FIRST DRAFT MINUTES

September 20, 2012 Standards Committee Meeting

RE: Minutes from the September 20, 2012 Standards Committee Meeting

SPECIFICATION, SPECIAL PROVISIONS AND DRAWINGS
REVISION TO STANDARD DRAWINGS

REVISE DESIGN MANUAL FIGURE 404-4D

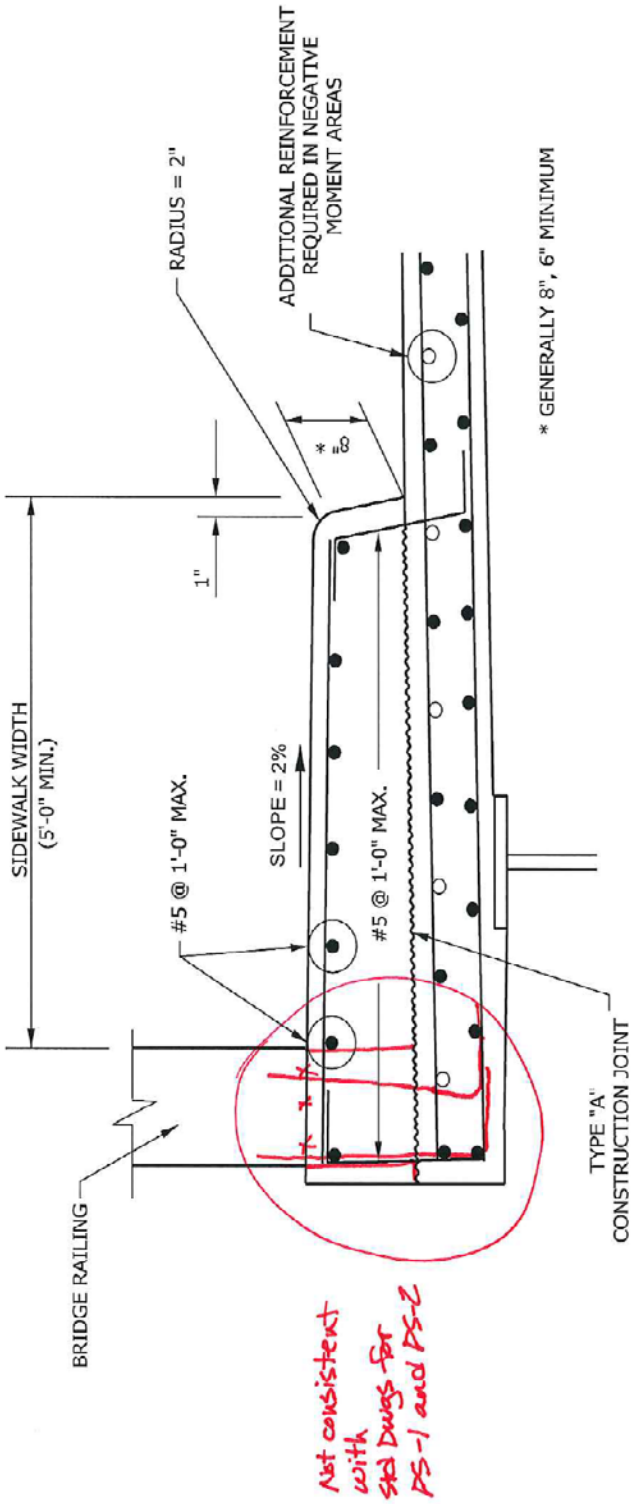
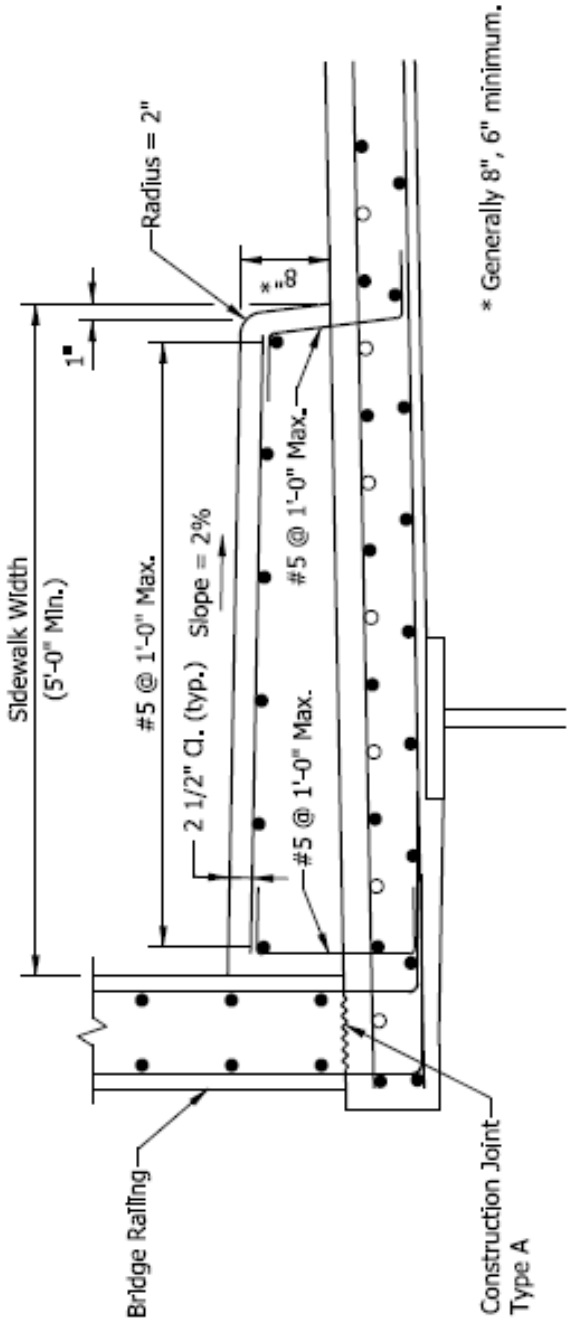
DISCUSSION: Ms. Phillips presented this item and stated that the drawing did not accurately reflect what is shown on the standard drawings.

PROBLEM(S) ENCOUNTERED: With the publication of corrected Standard Drawings 706-BRPP-03 and -04, the bridge railing construction shown in Design Manual Figure 404-4D is no longer consistent with the Standard Drawings for pedestrian bridge rail in combination with a concrete sidewalk. The concrete bridge rail should not be shown sitting atop the sidewalk.

PROPOSED SOLUTION: Revise the Design Manual Figure 404-4D for consistency with the pedestrian bridge rail Standard Drawings 706-BRPP-03 and -04. See attached markup and final draft of proposed revised figure.

EXISTING STANDARD DRAWING 802-SNGP-01 SIGN PLACEMENT (WITH MARKUPS)

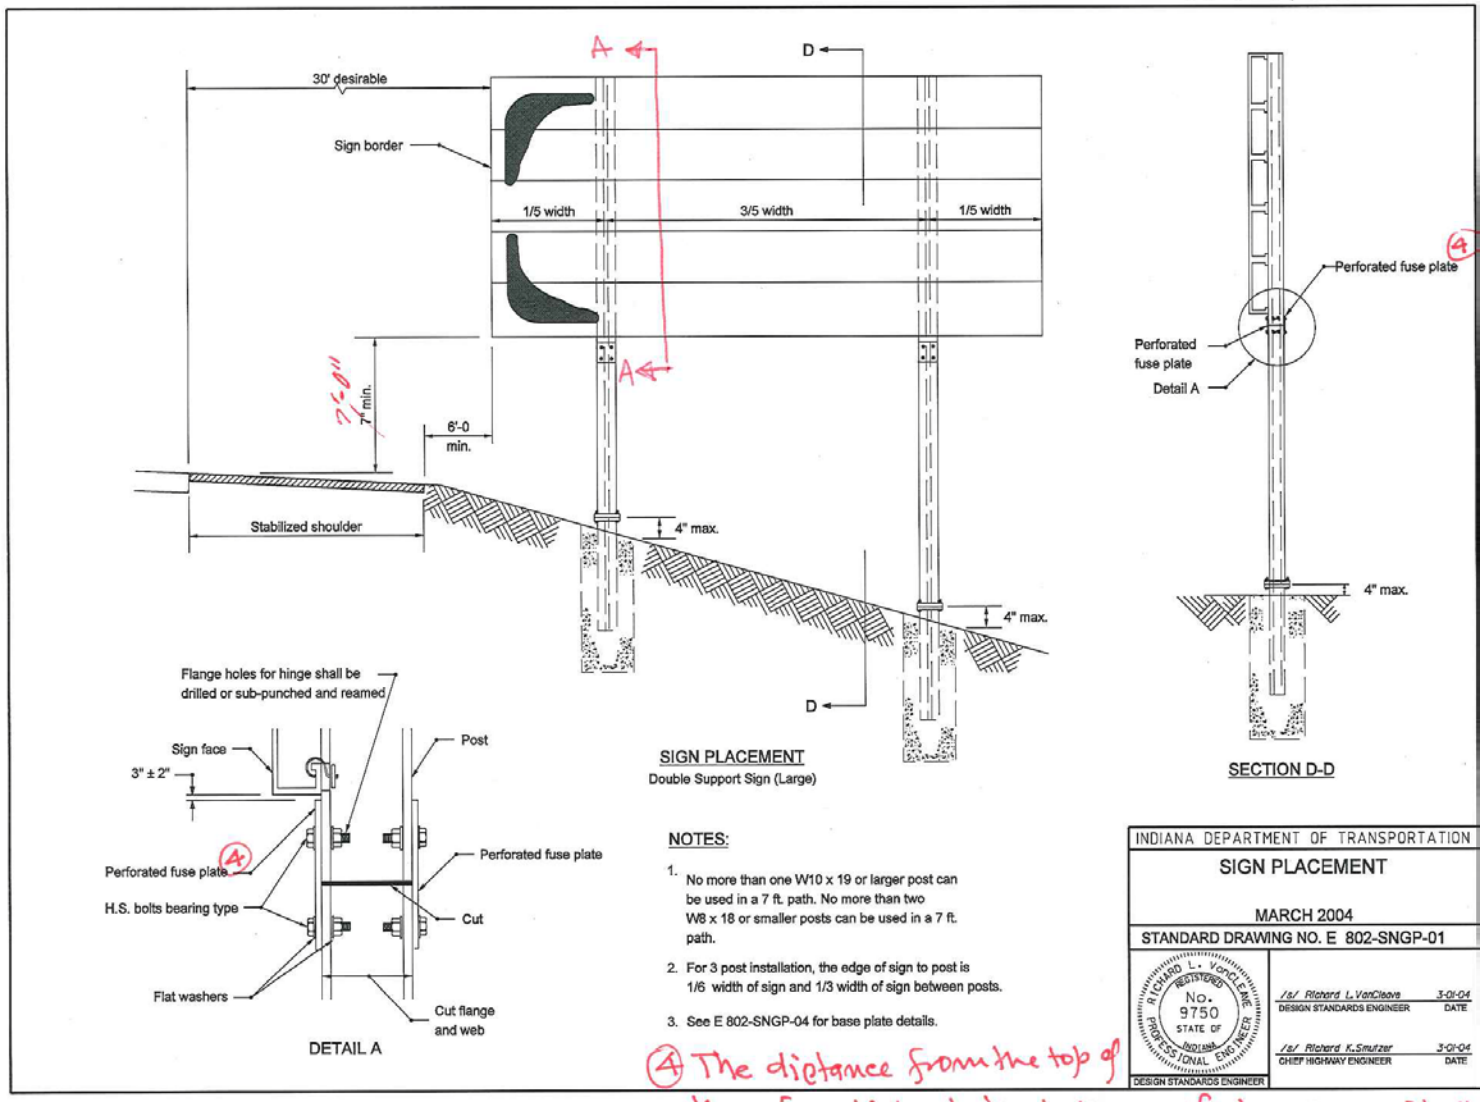
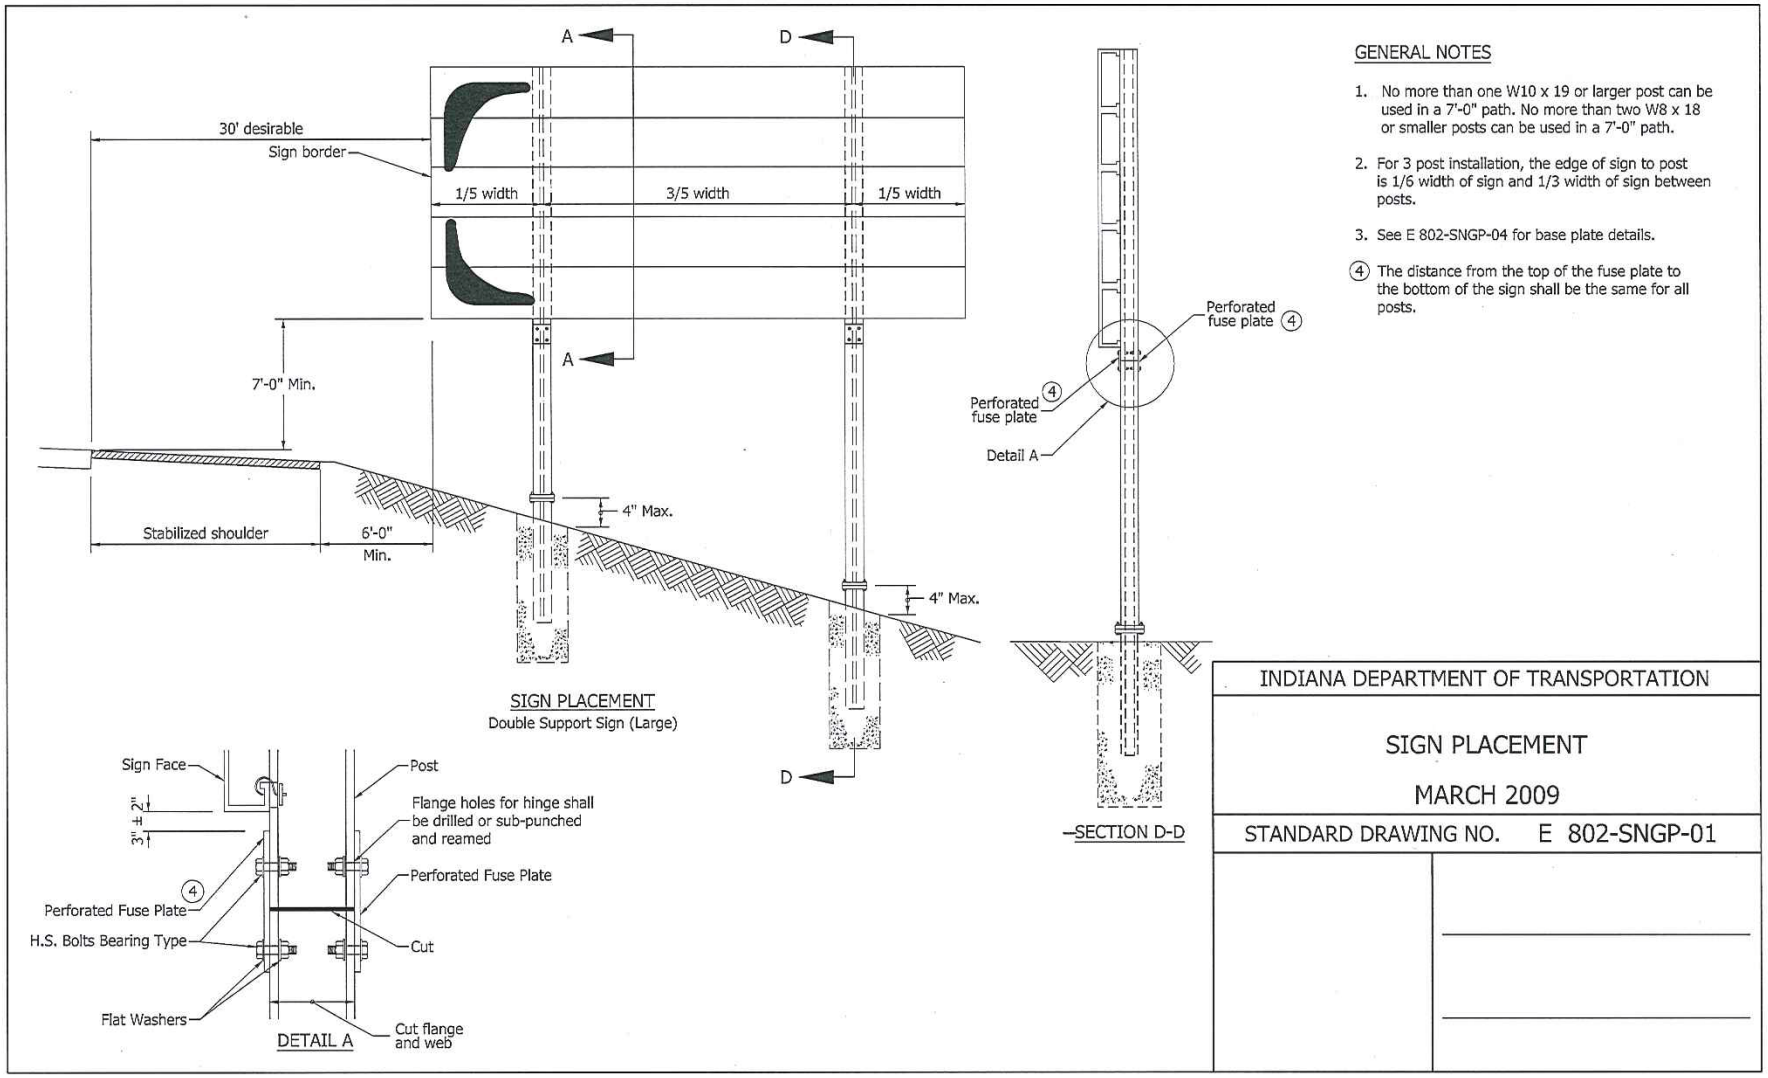
1. On panel sign assemblies the distance between the bottom of the panel sign and the top of the fuse plate often varies from one post to the other in the same assembly. This may lead to the breakaway mechanism not functioning correctly.

DISCUSSION: Mr. Boruff presented this item as described on the proposal sheet. Mr. Garg stated that at the time of a hit, it would not behave the way it should, so the note was added for clarification.

1. Add a note to Standard drawing 802-SNGP-01 that "The distance from top of the fuse plate to the bottom of the sign shall be the same for all posts"

(4) The distance from the top of the fuse plate to the bottom of the sign shall the same for all posts.

EXISTING STANDARD DRAWING 802-SNGP-03 SIGN PANEL DETAILS (WITH MARKUPS)

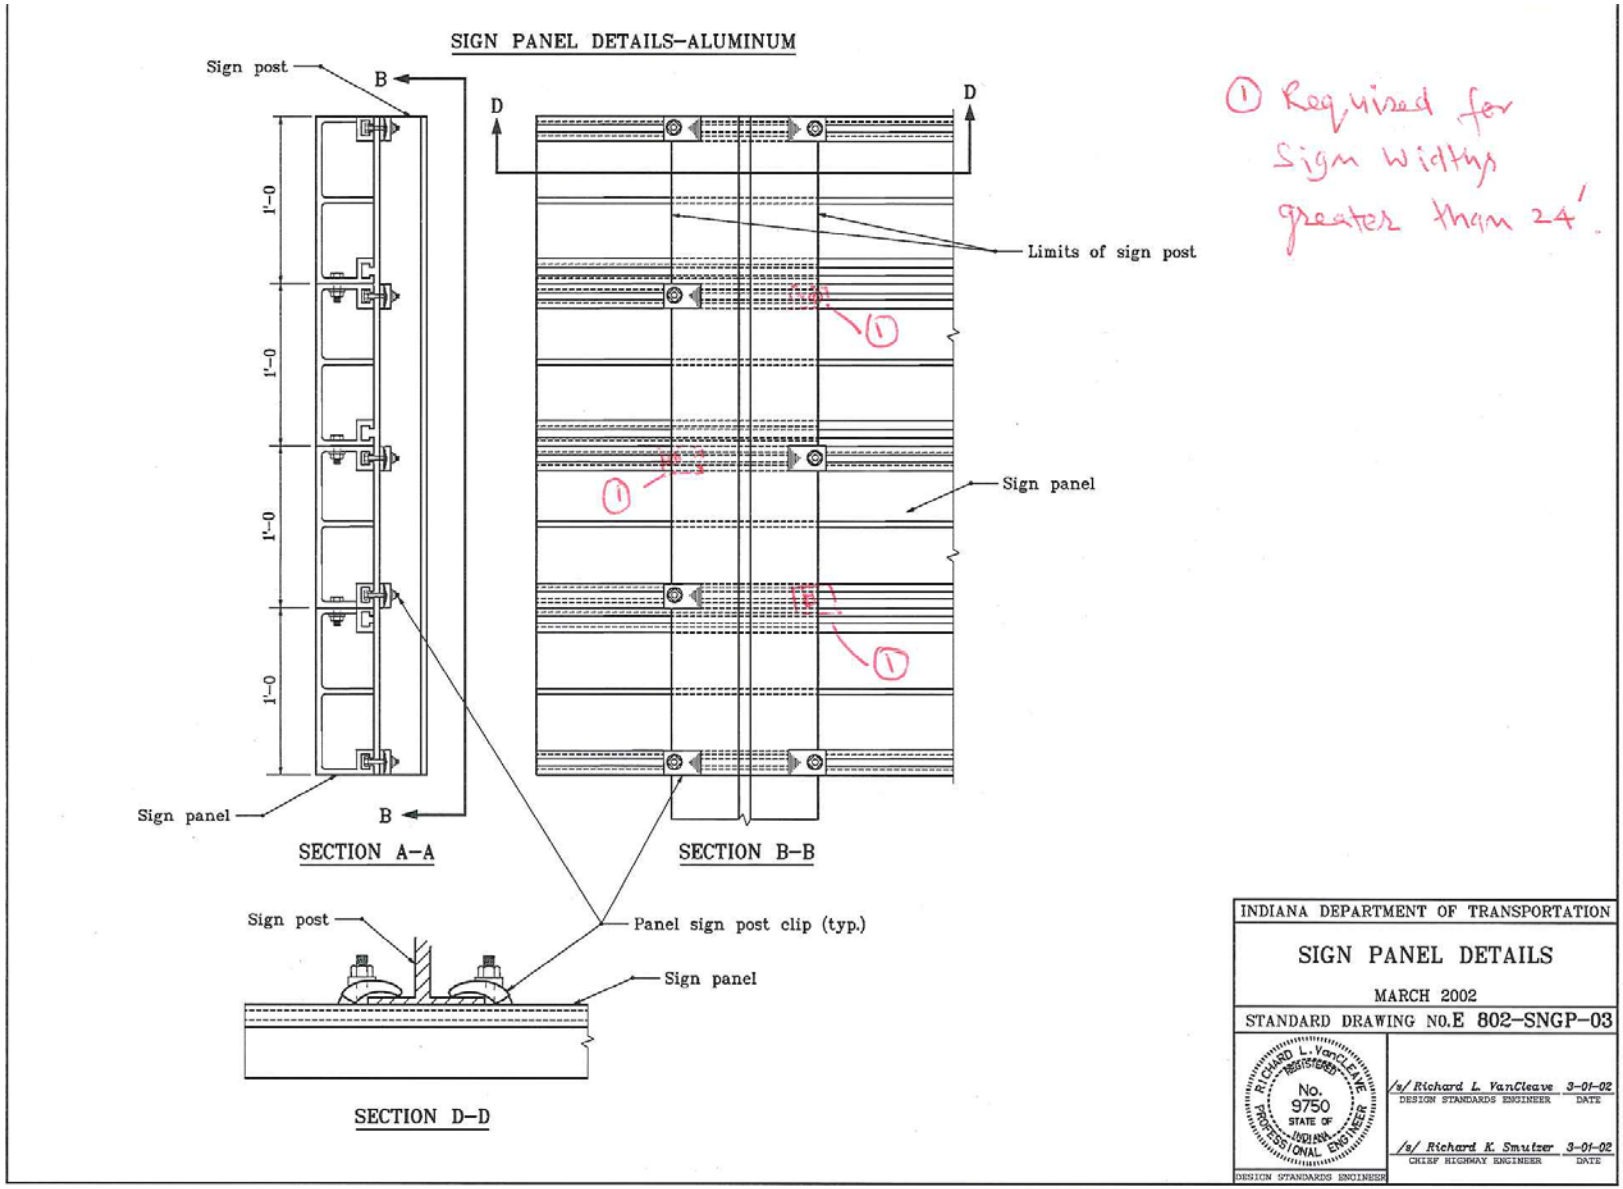
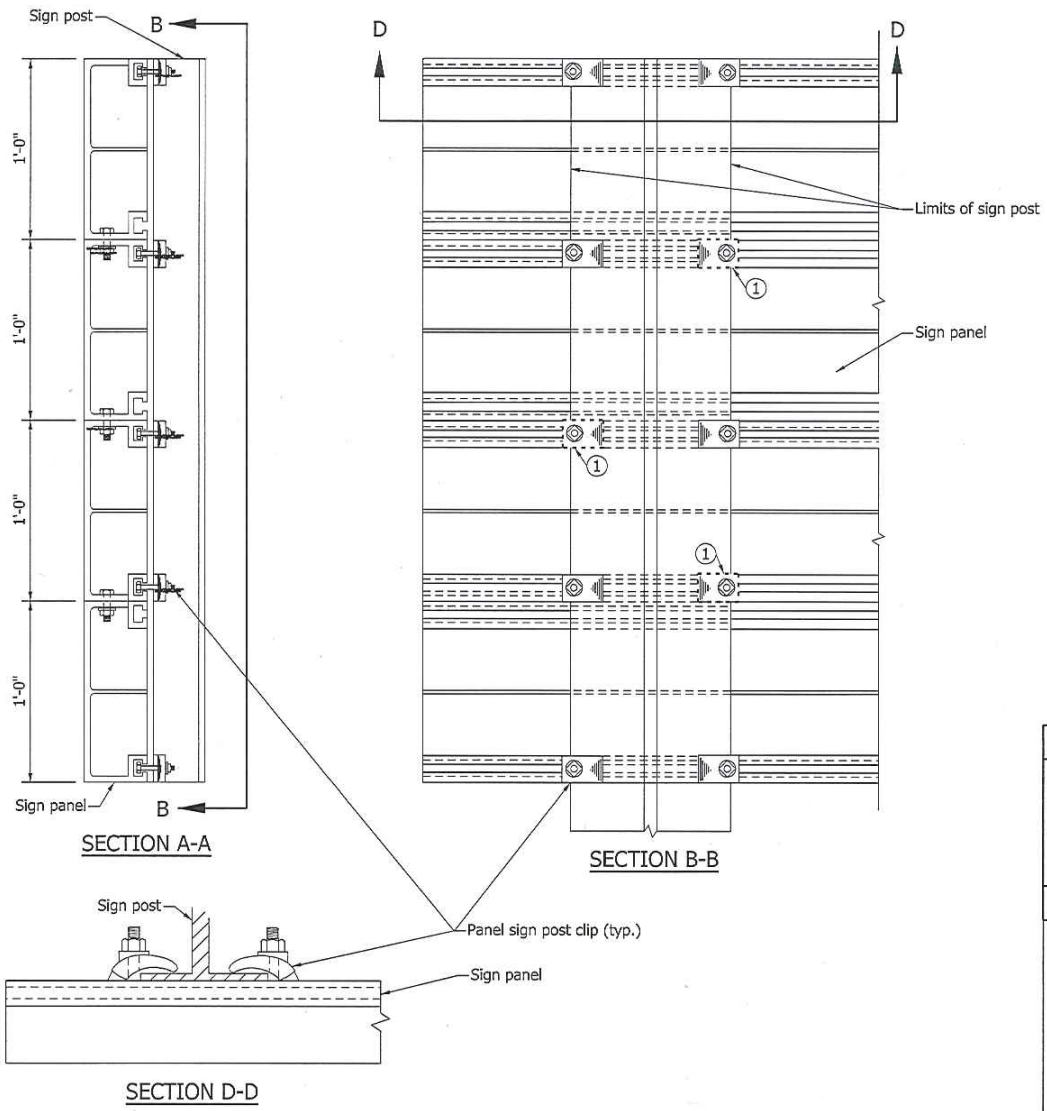
2. Clips that attach the sign panel to the support I-beams are not being installed on both sides of the I-beam for signs wider than 24' as they should be. This makes it more likely that the sign will separate from the supports.

Mr. Boruff continued his explanation of the drawing revisions in regards to clips. Mr. Pankow inquired about the size of the signs and how this applies. Mr. Miller expressed concerns about signs that have blown down following heavy storms. Mr. Garg said that is due to the design of the fuse plate, and they are looking into revising that plate, due to the fatigue on that fuse plate.

2. Revise Standard drawing 802-SNGP-03 to indicate that clips on both the left side and right side of the posts are required for signs wider than 24'.

1. Required for sign width greater than 24 feet.
